WOODHAVEN PARK PHASE 2

SHERWOOD, OREGON

BID SET

COVER SHEET
WOODHAVEN PARK PHASE 2
SHERWOOD, OREGON

**OVERALL SITE PLAN
 WOODHAVEN PARK PHASE 2
 SHERWOOD, OREGON**

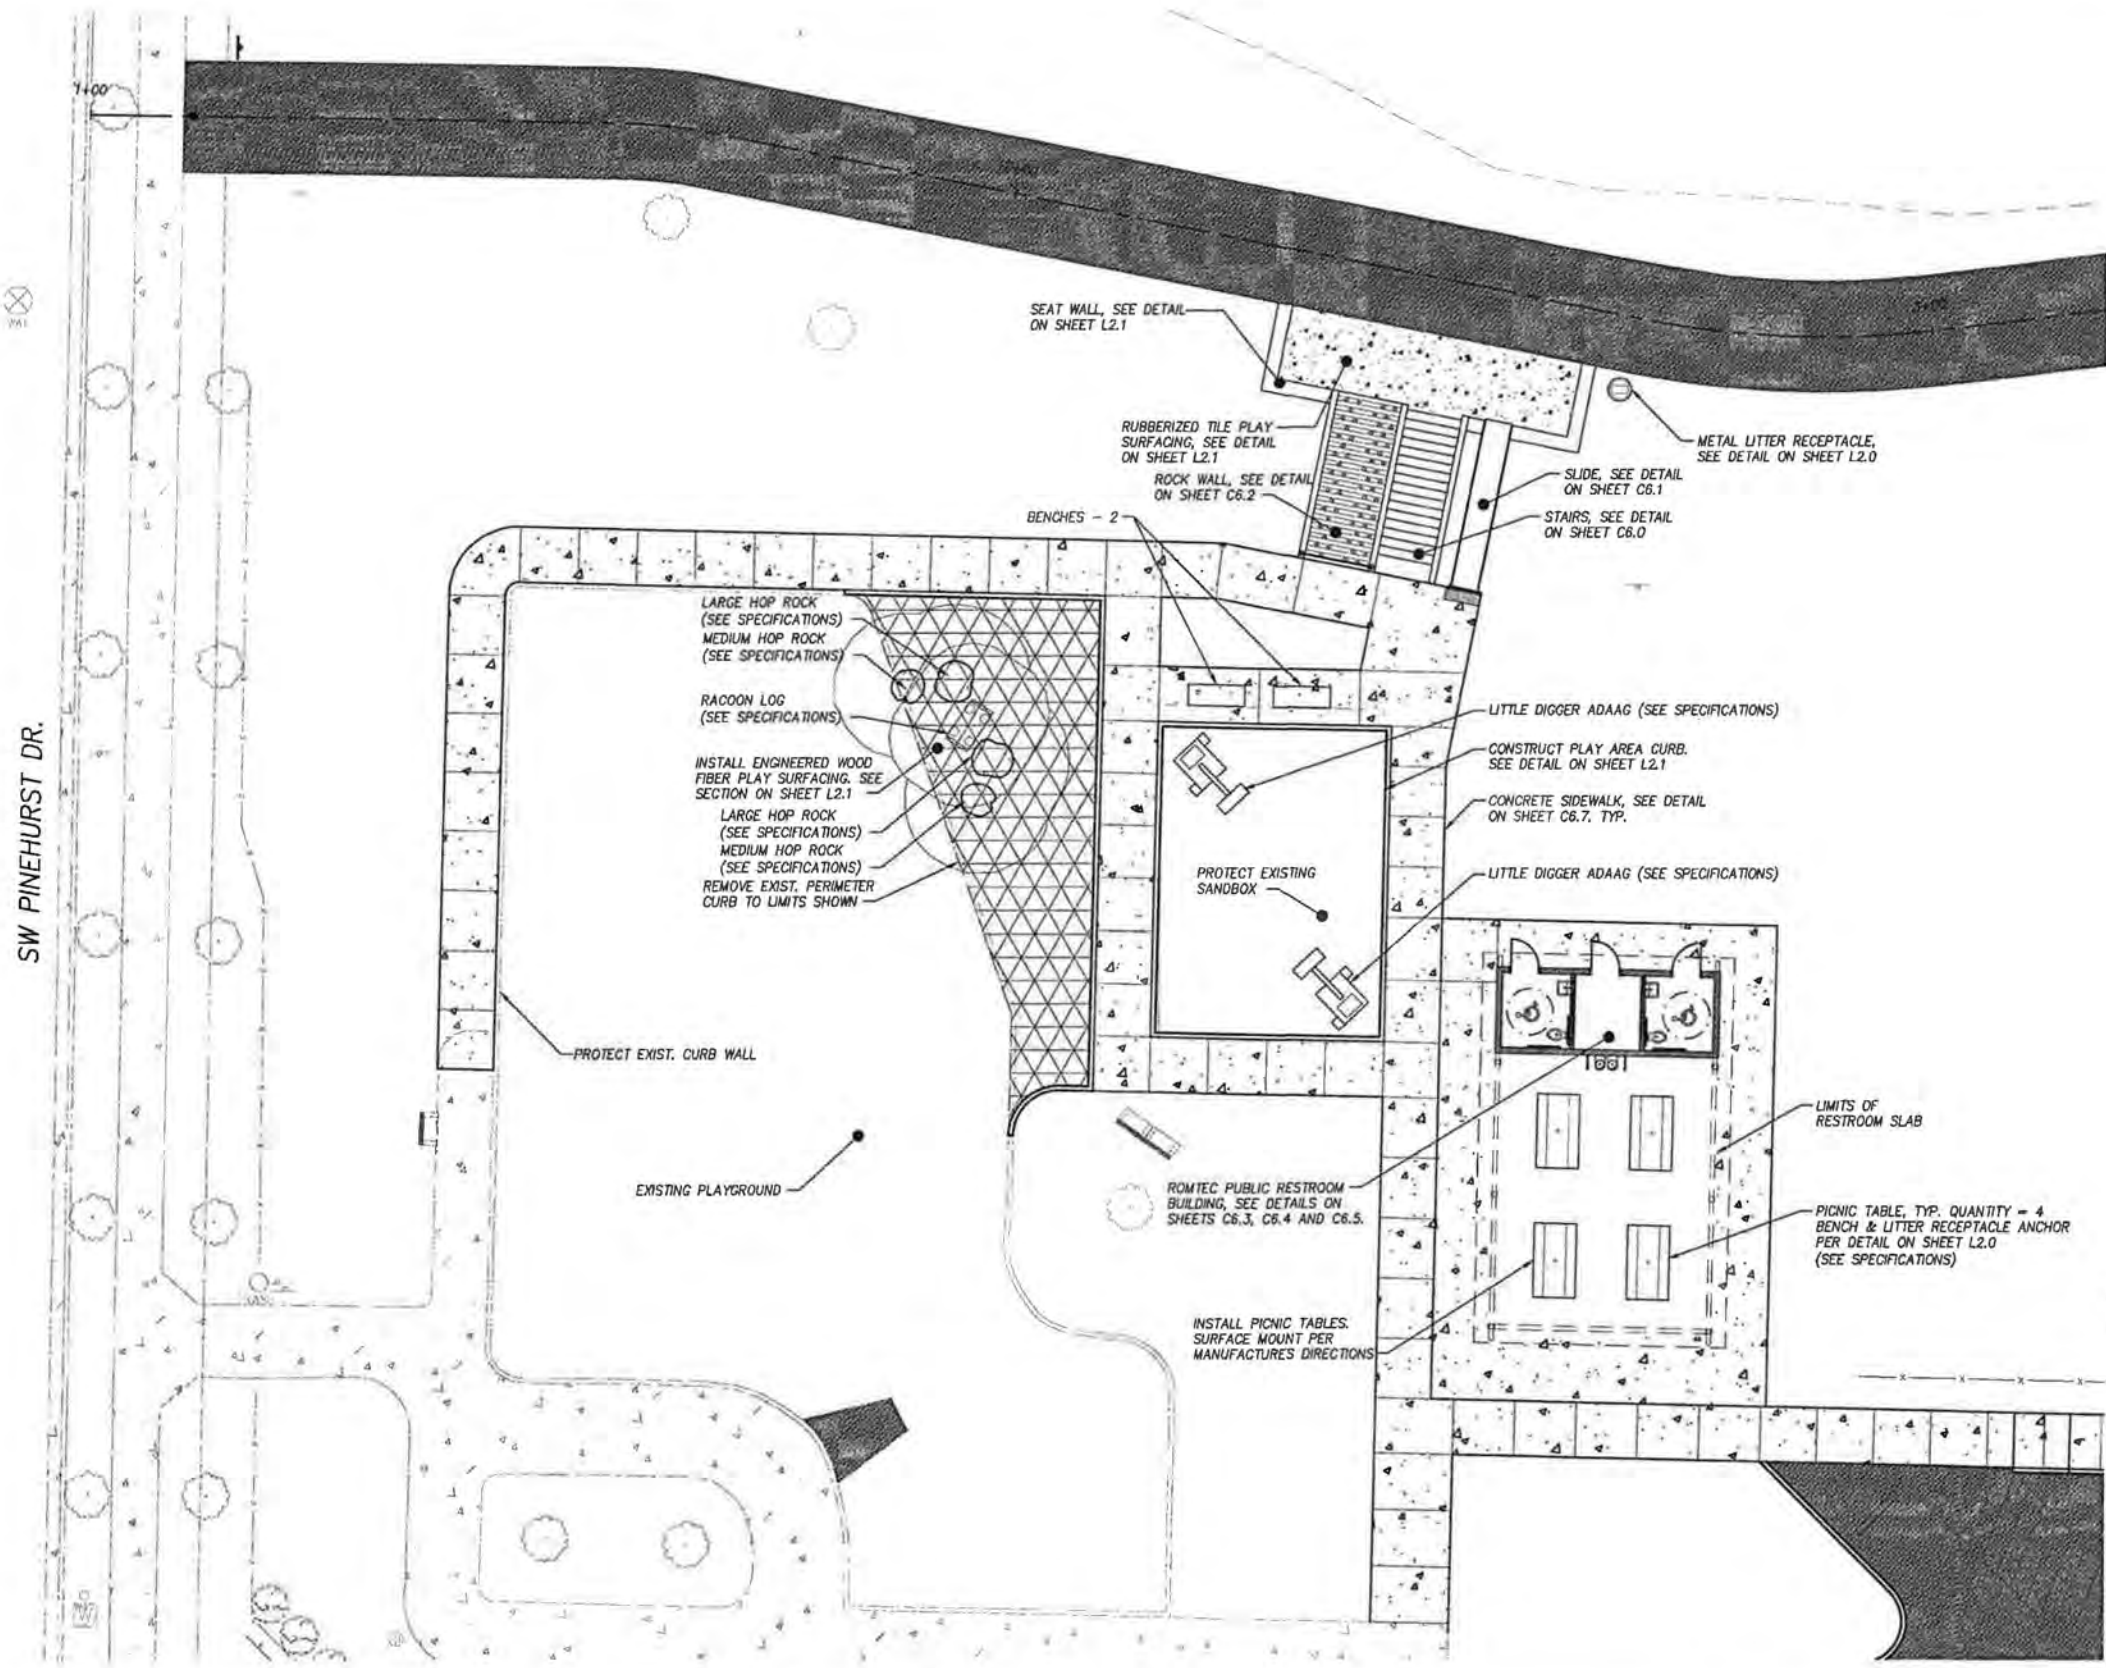
- DELETED FROM PROJECT PHASE
- MATERIAL CHANGE PROJECT PHASE (WOOD CHIP)
- ADDED ALIGNMENT CHANGE

**PLAYGROUND PLAN
WOODHAVEN PARK PHASE 2
SHERWOOD, OREGON**

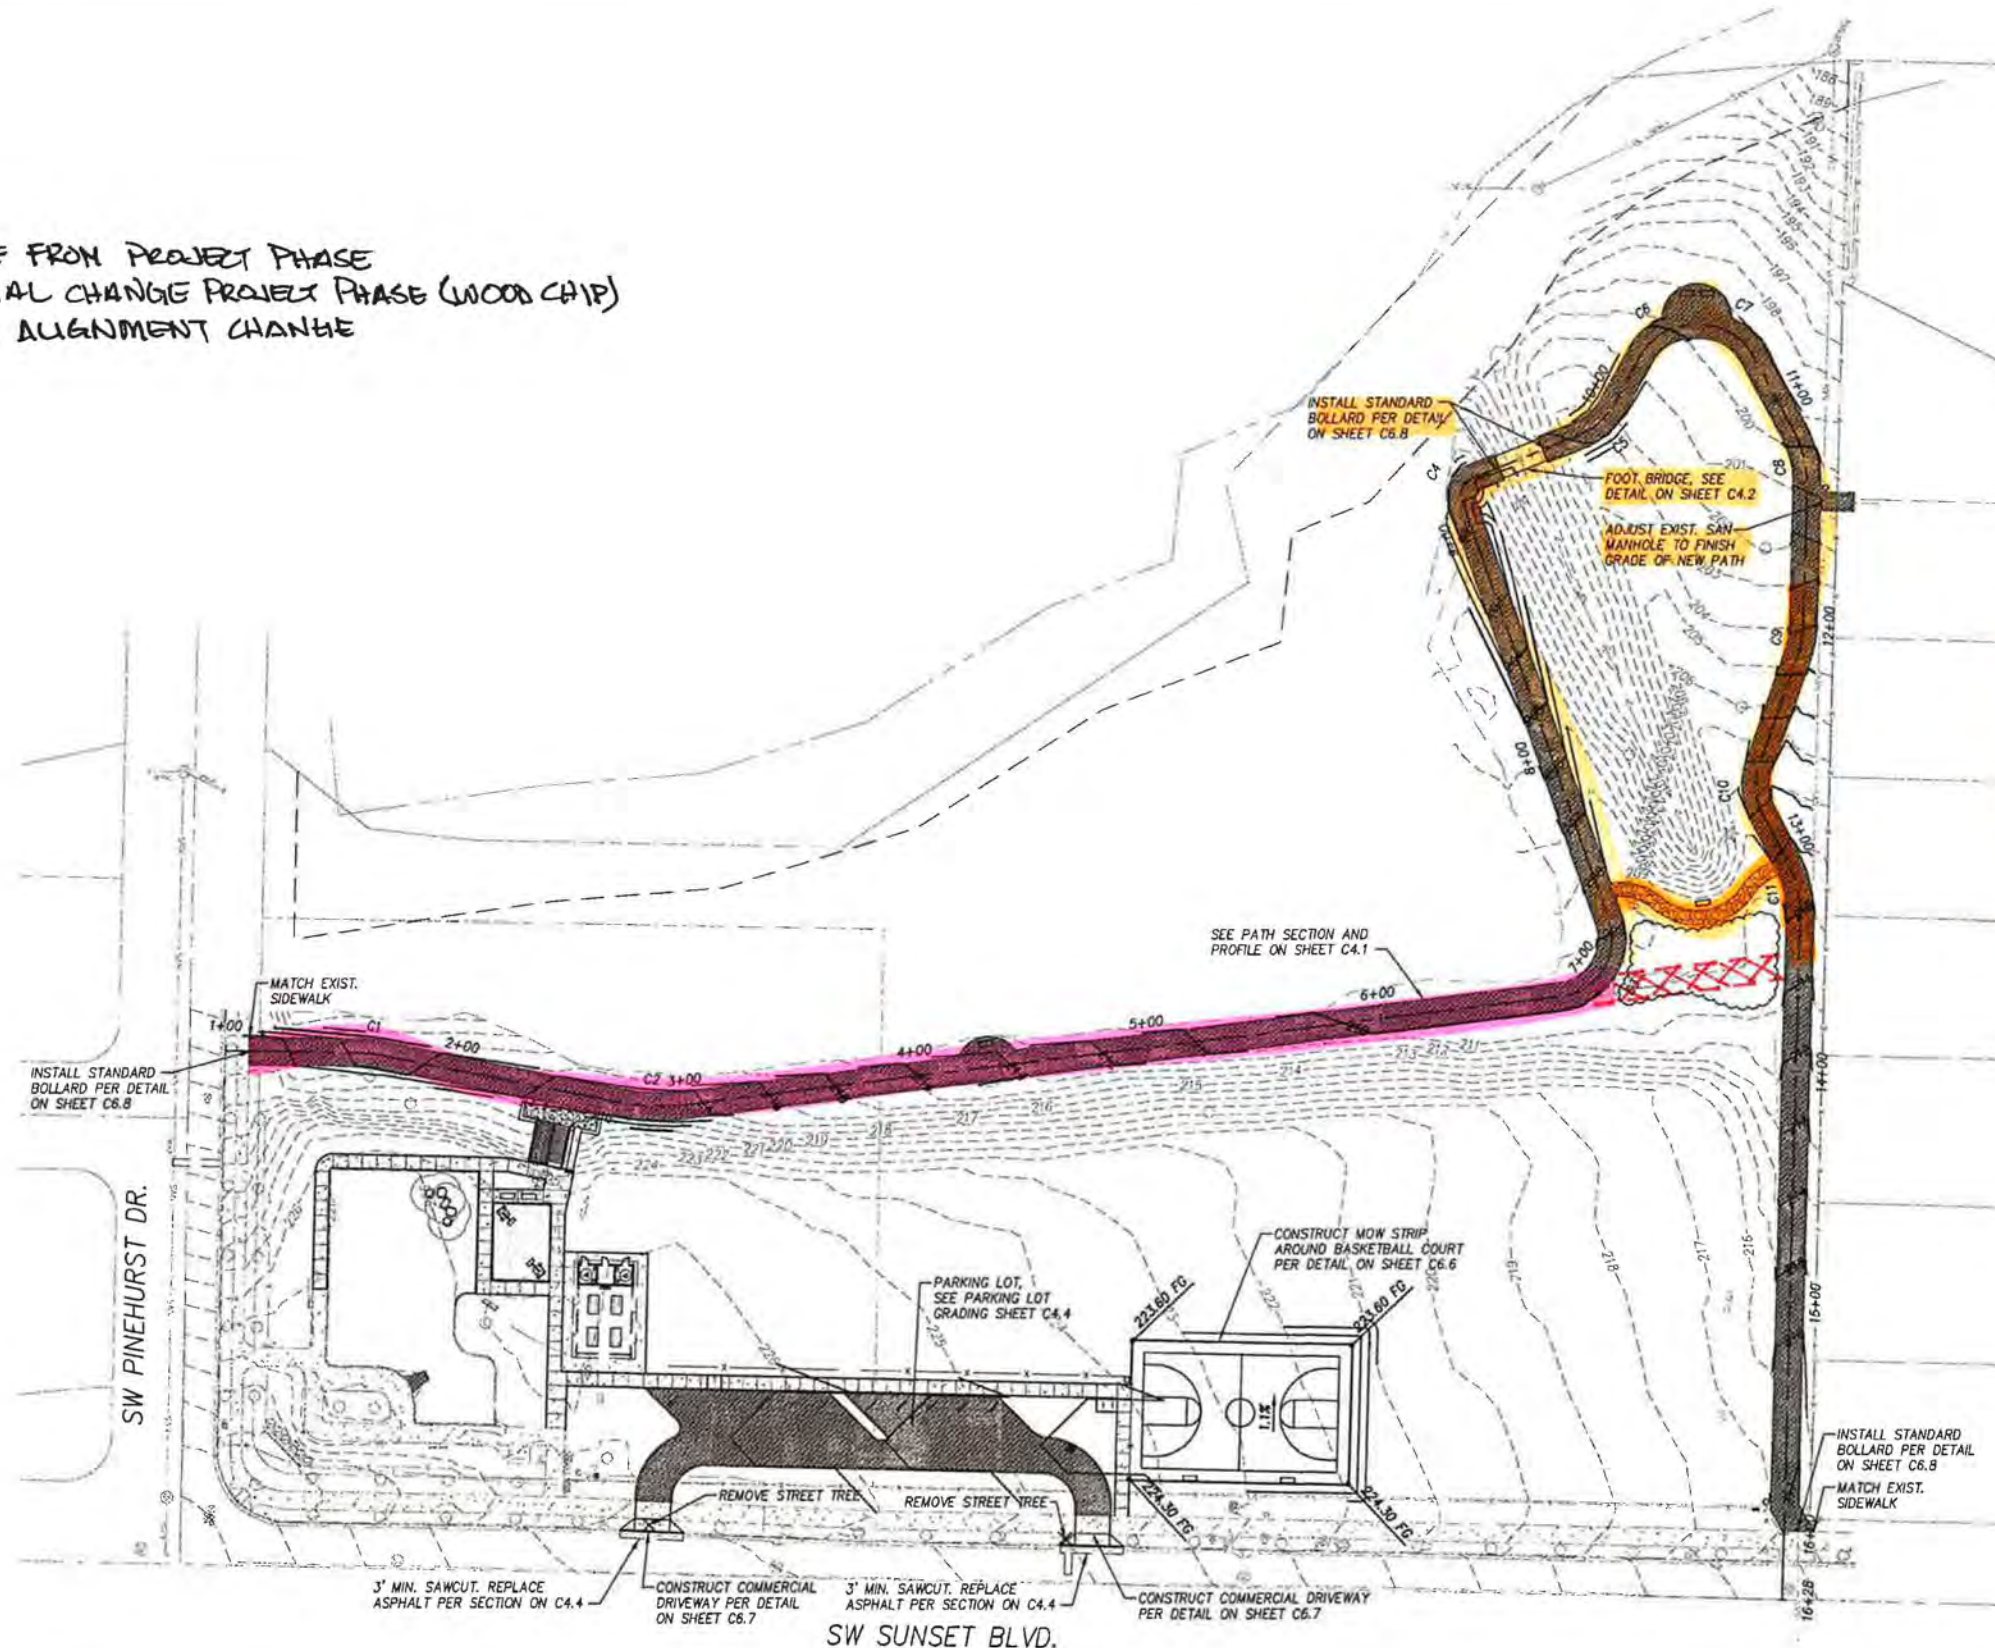
DELETE FROM PROJECT PHASE
 MATERIAL CHANGE PROJECT PHASE (WOOD CHIP)
 ADDED ALIGNMENT CHANGE

SHEET NO. **C4.1**

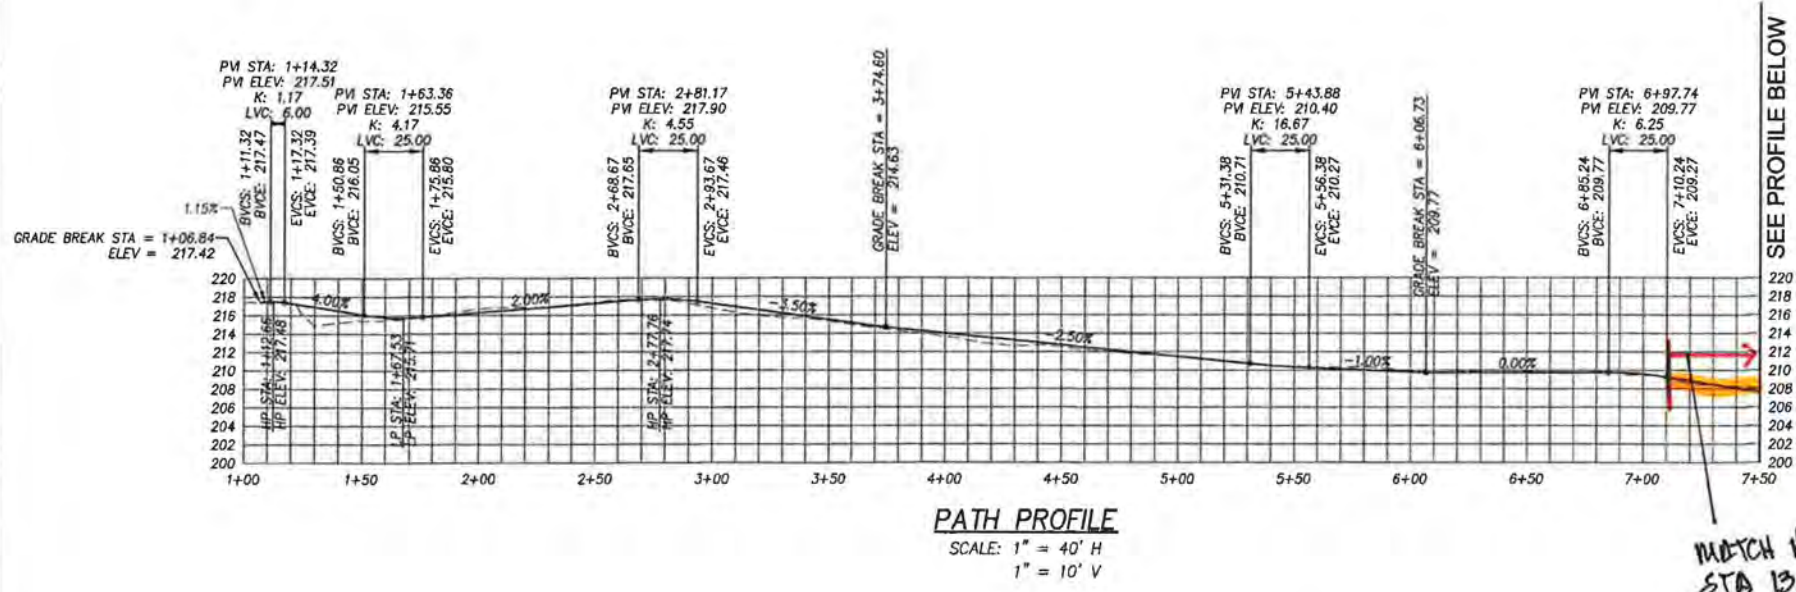
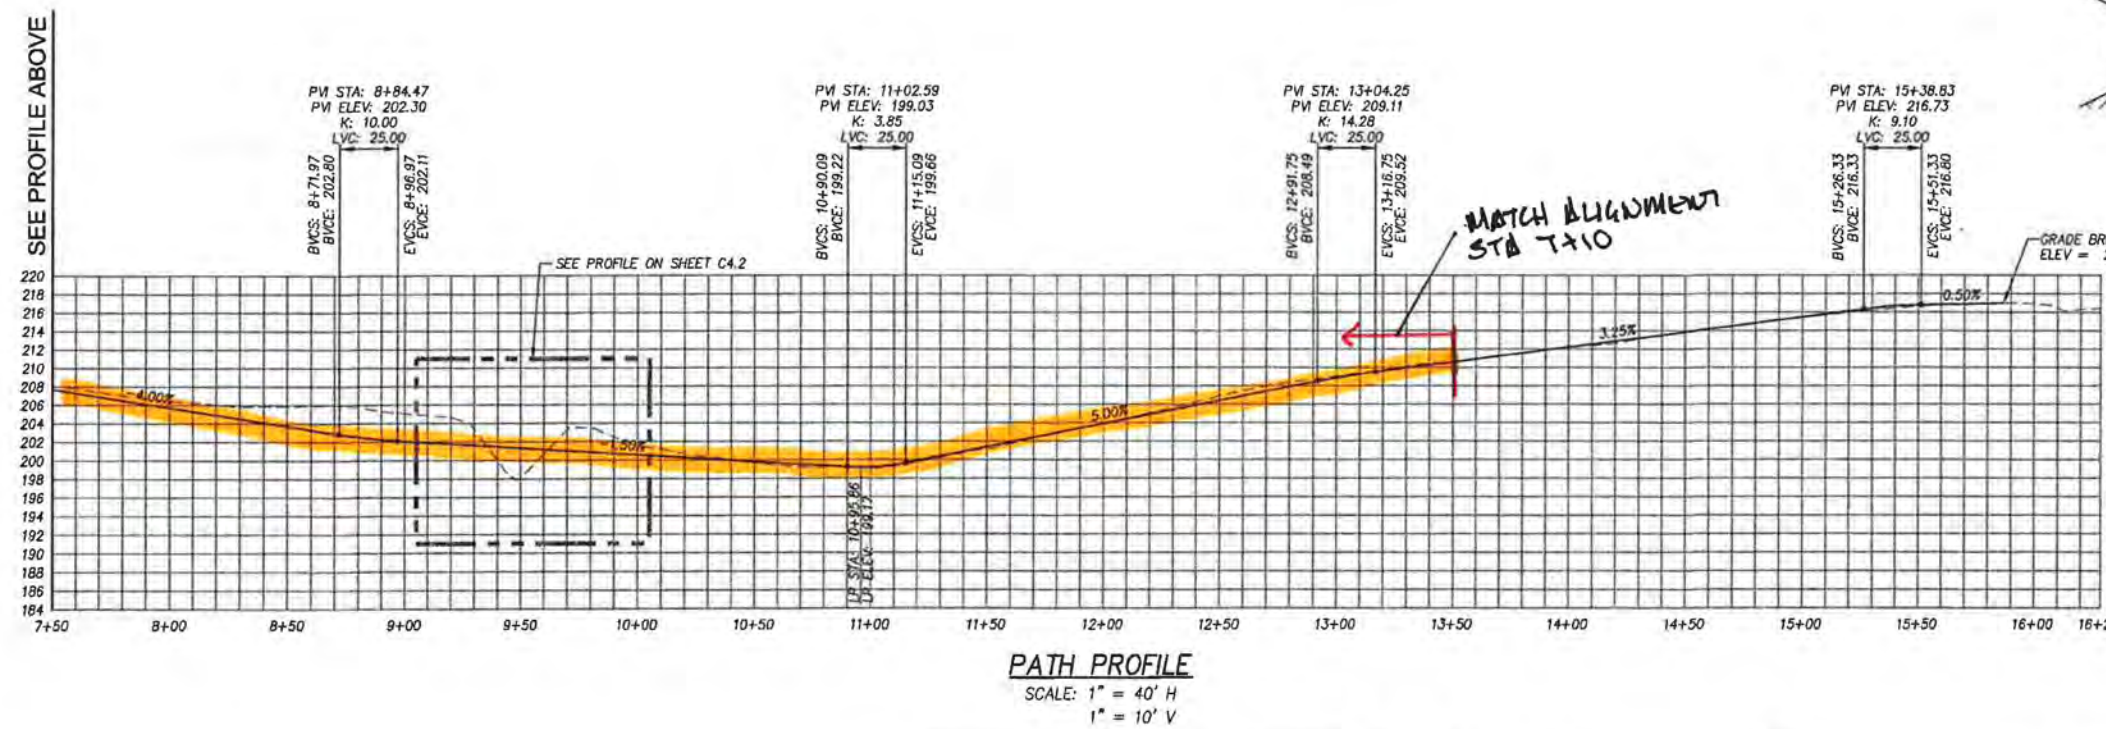
DELETE FROM PROJECT PHASE
 MATERIAL CHANGE PROJECT PHASE
→ ADDED ALIGNMENT CHANGE

PEDESTRIAN BRIDGE PROFILE
WOODHAVEN PARK PHASE 2
SHERWOOD, OREGON

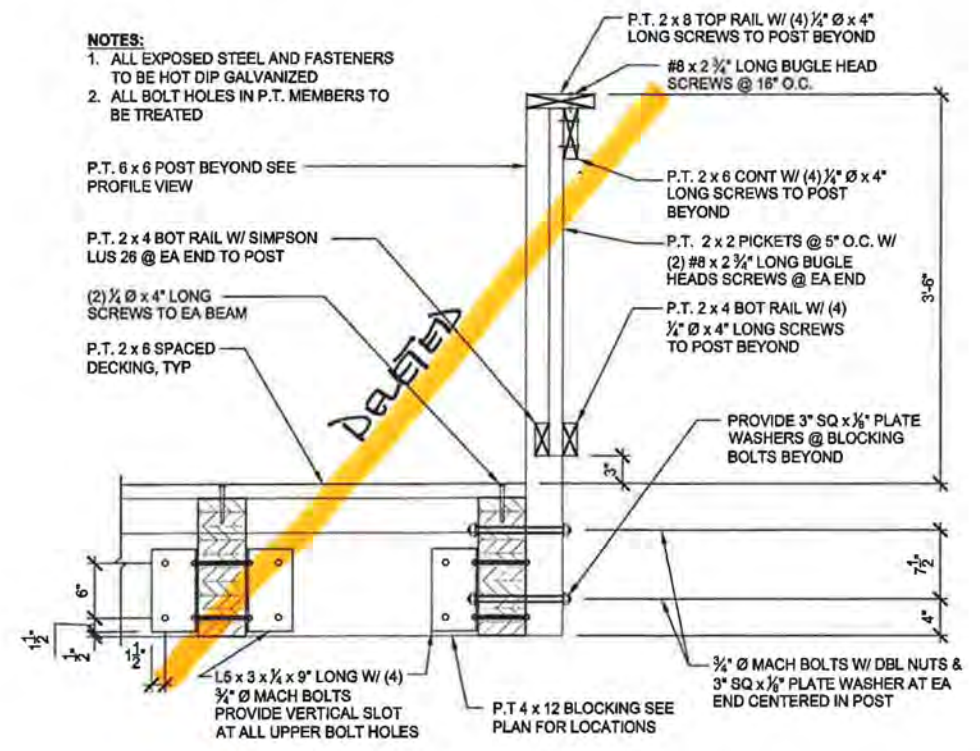
DELETED FROM PROJECT PHASE
